REVISED RESPONSE TO REQUEST FOR ADDITIONAL INFORMATION**APR1400 Design Certification****Korea Electric Power Corporation / Korea Hydro & Nuclear Power Co., LTD****Docket No. 52-046****RAI No.: 318-8337****SRP Section: 15.06.05 – Loss of Coolant Accidents Resulting From Spectrum of Postulated Piping Breaks Within the Reactor Coolant Pressure Boundary****Application Section: 15.6.5****Date of RAI Issue: 11/24/2015****Question No. 15.06.05-2****SBLOCA Break Spectrum Analysis & Core Two-Phase Level**

Response – (Rev. 1)

Figure 15.6.5-24A 465 cm² (0.5 ft²) Break in Pump Discharge Leg: Normalized Total Core Power

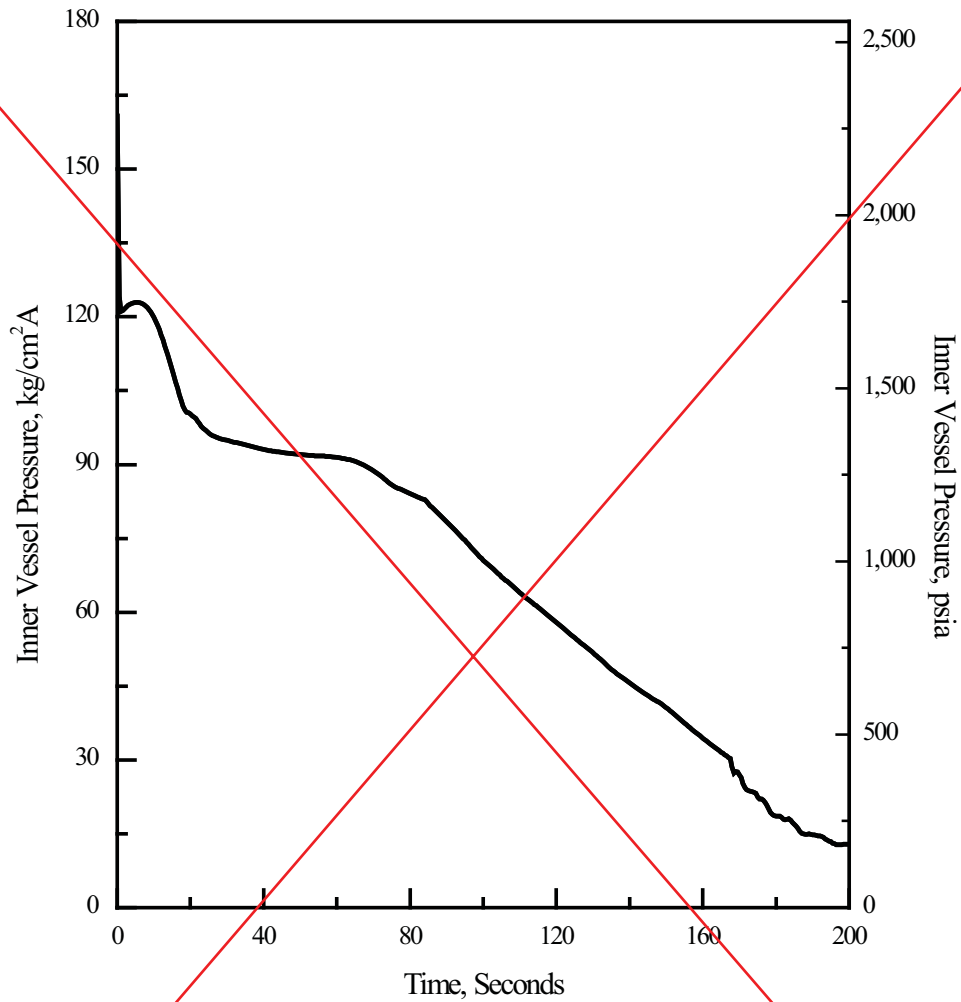
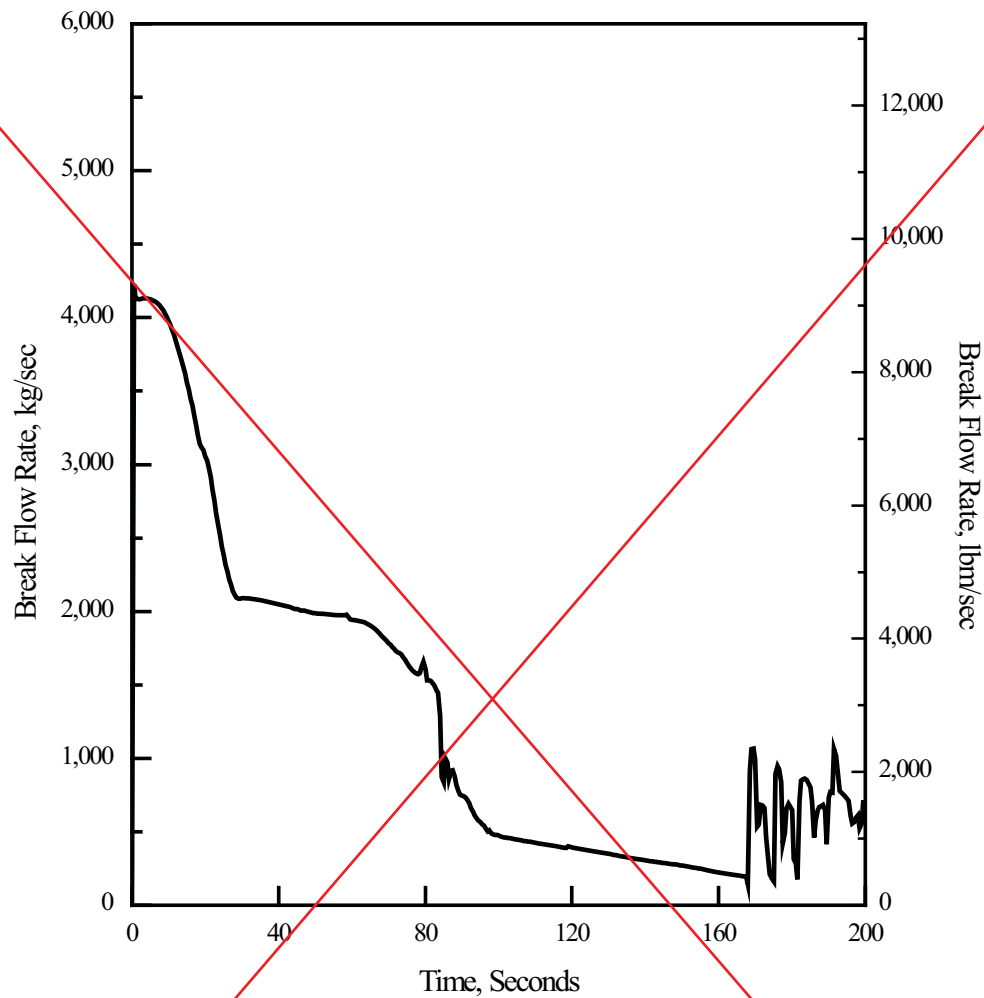
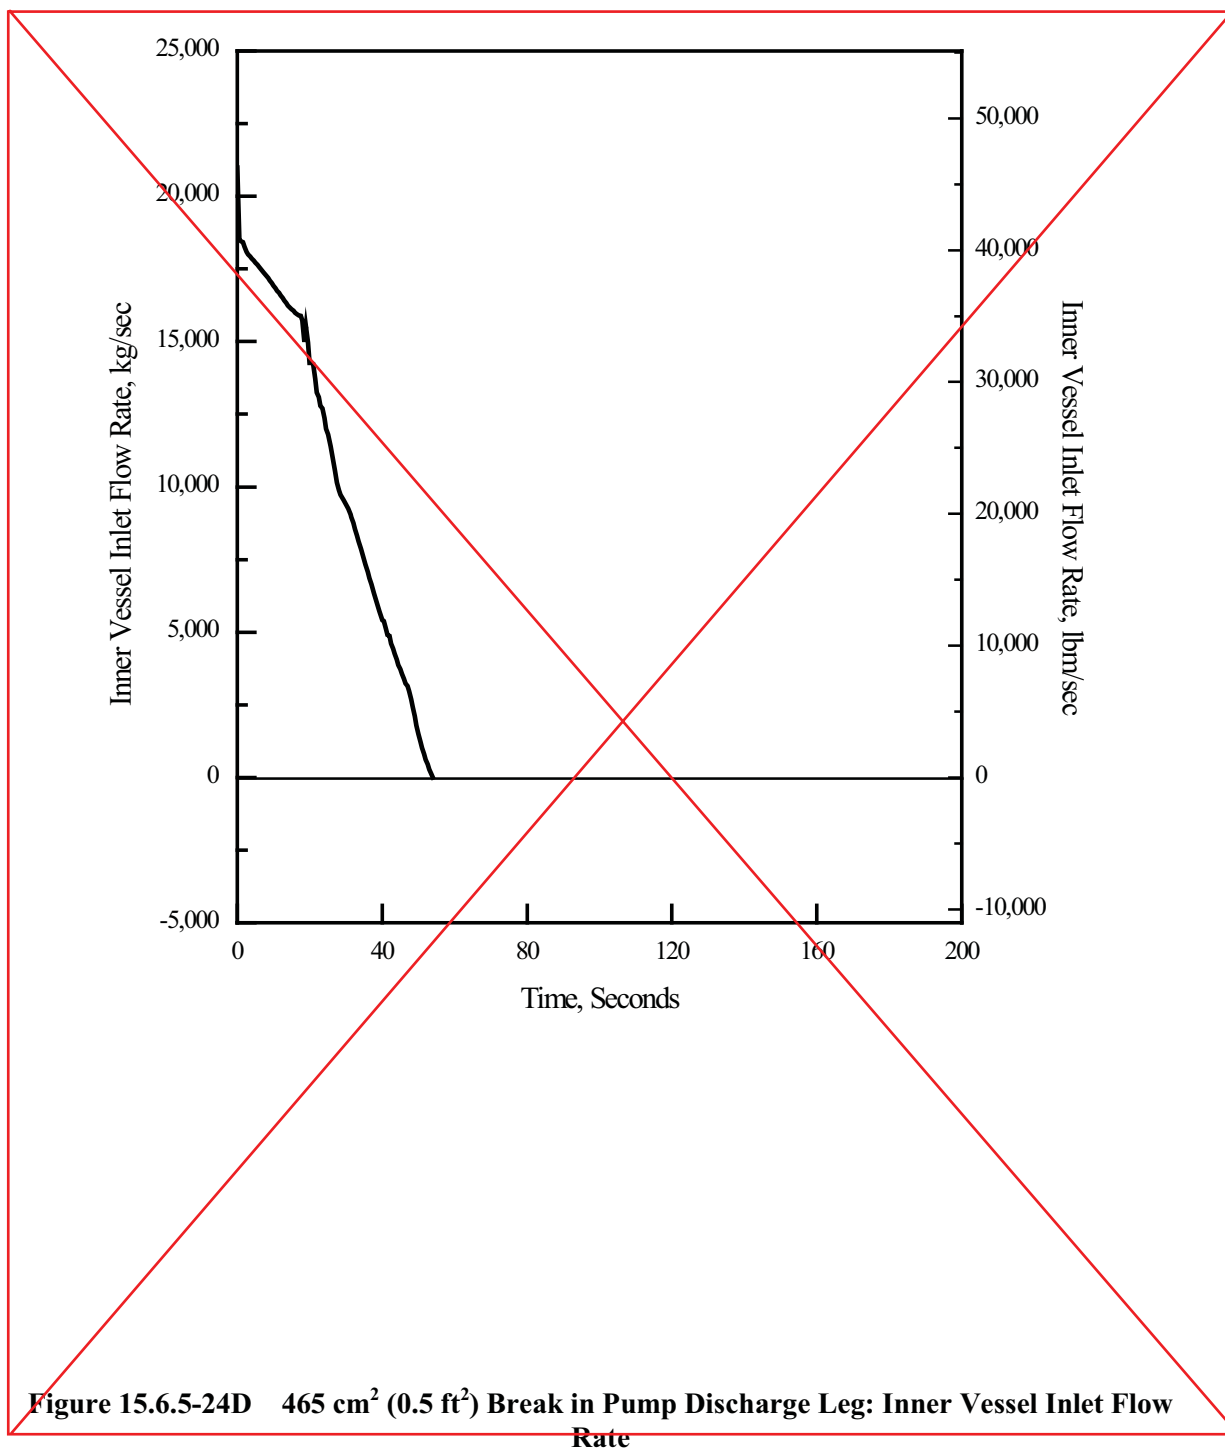
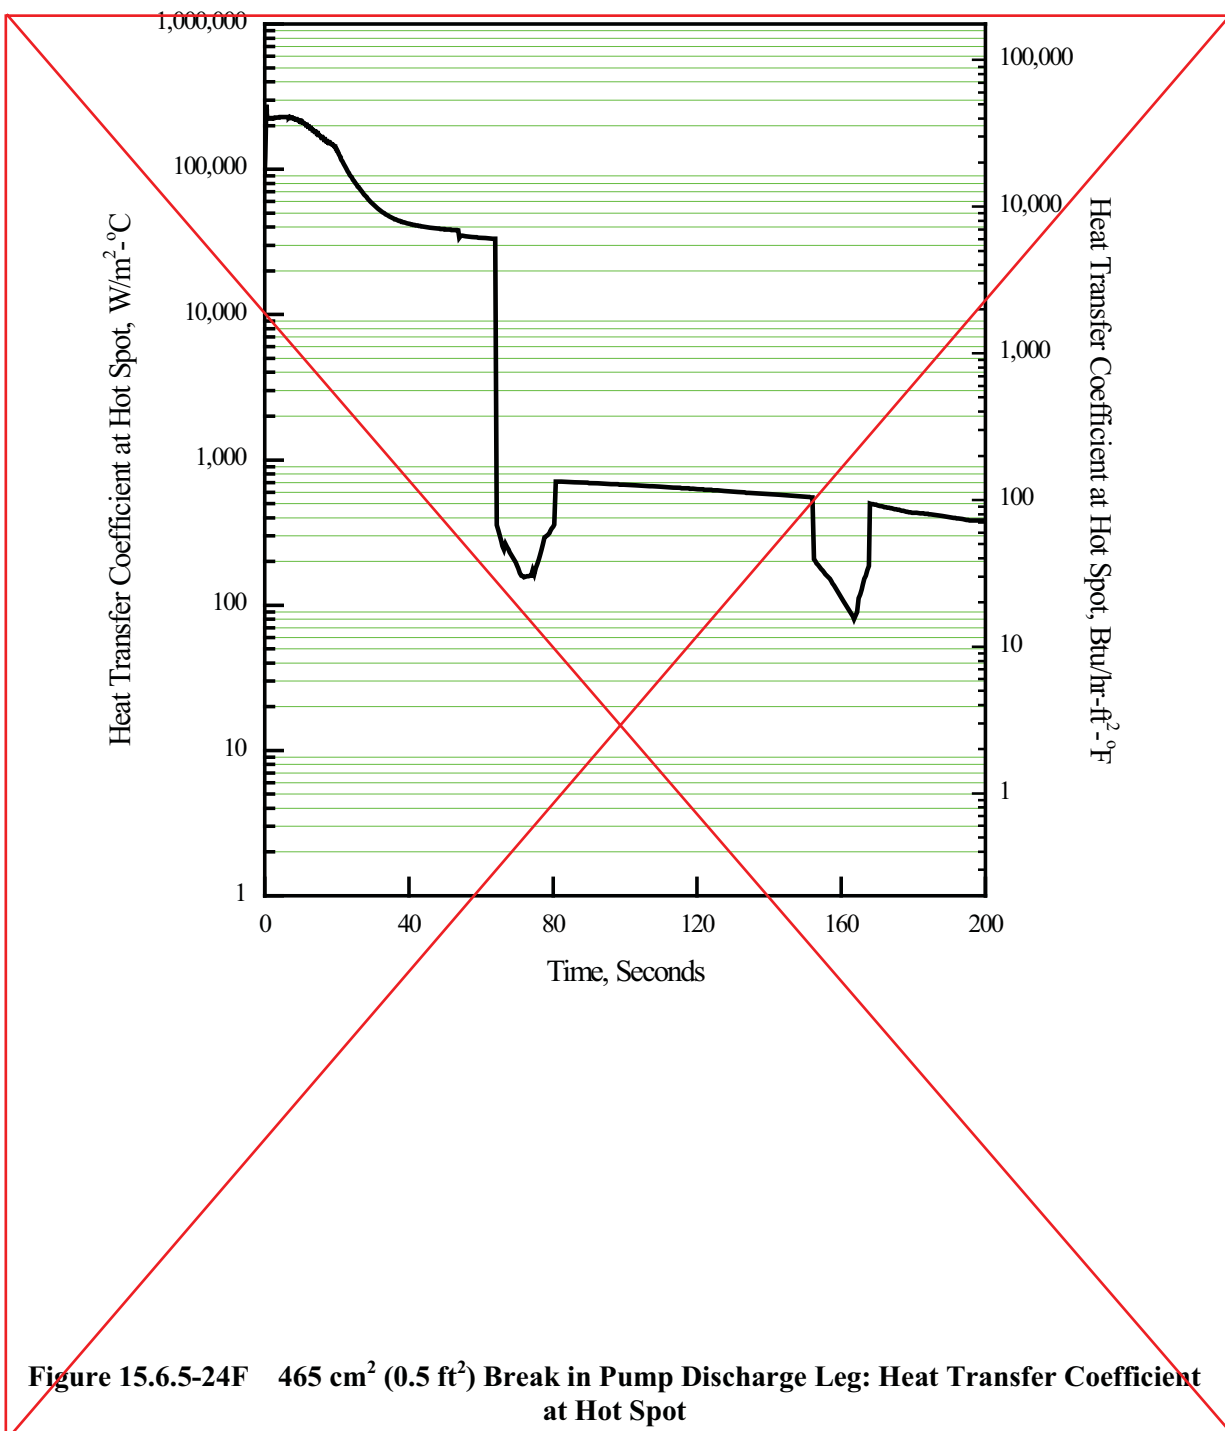
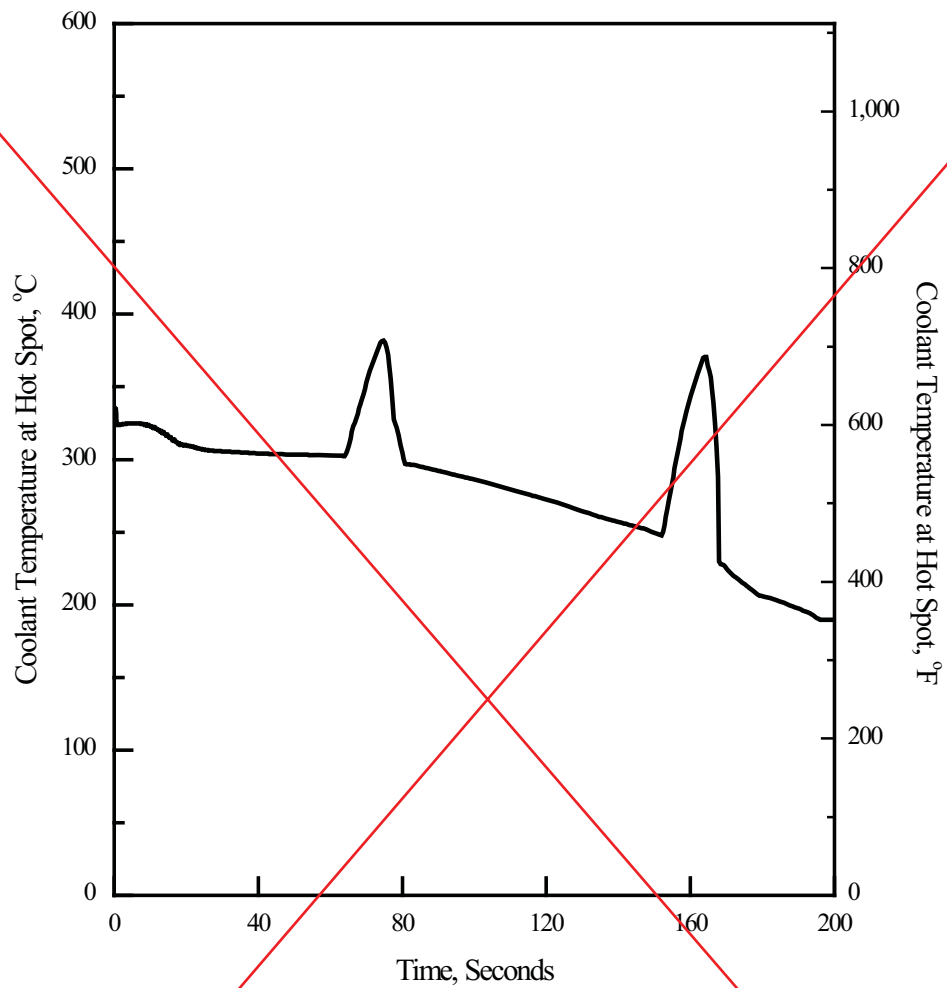
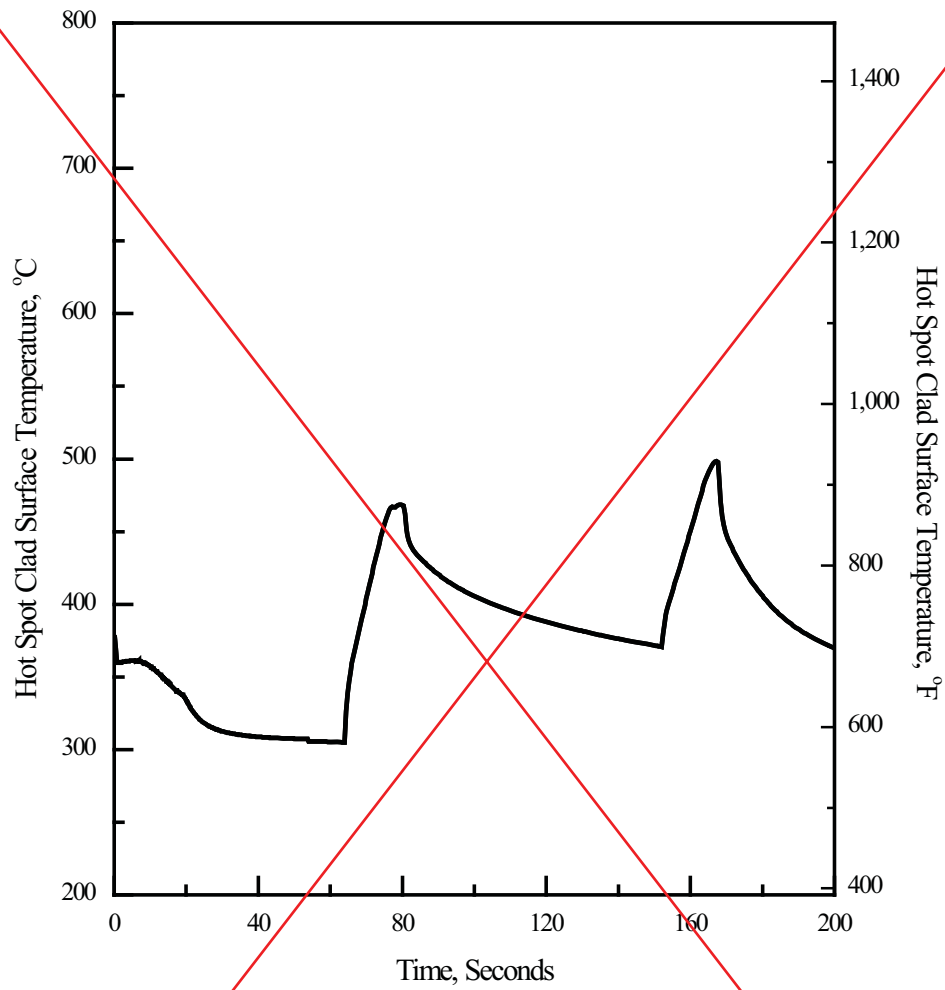
Replace with A

From Figure 15.6.5-24A

to Figure 15.6.5-25H

Figure 15.6.5-24A 126.7 cm² (0.1364 ft²) Break in DVI Line: Normalized Total Core Power
